FURTHER FEEDBACK ON CBA MODELLING

2 Benefits in the revised HVDC workbook have been overestimated due to errors

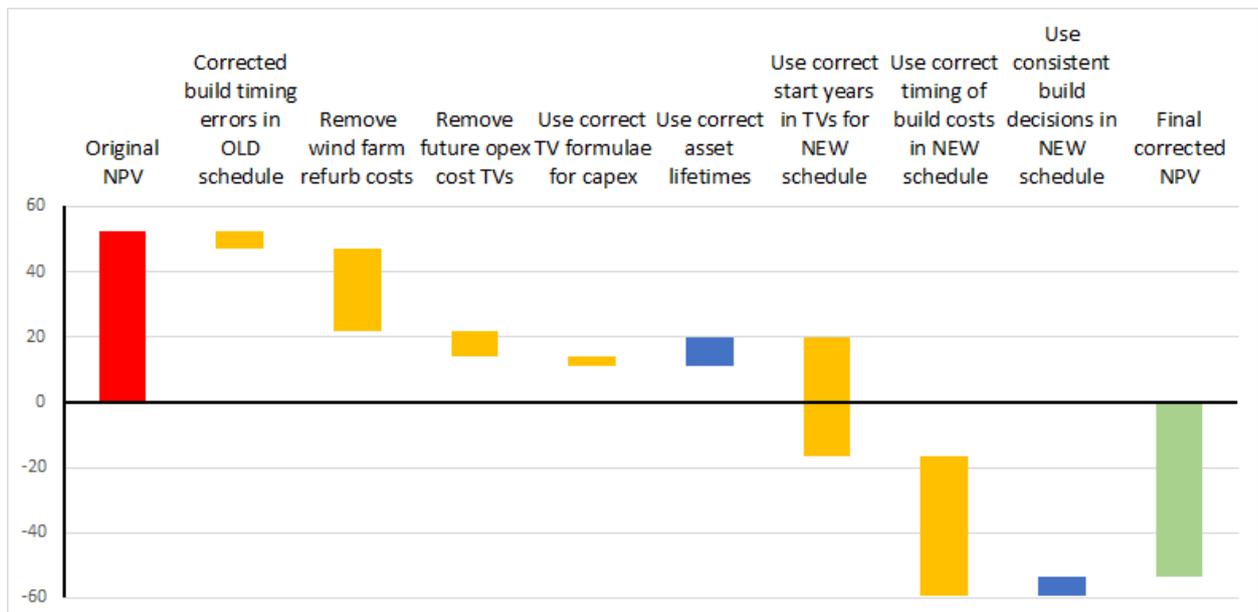
2.2.7 In summary, after amending the revised HVDC workbook to account for the errors and issues identified by HoustonKemp, we calculate a **net cost of \$53.3 million** from removing the current HVDC charge, instead of the net benefit of \$52.3 million estimated by OGW. The waterfall chart of the differences between the two estimates is shown below:
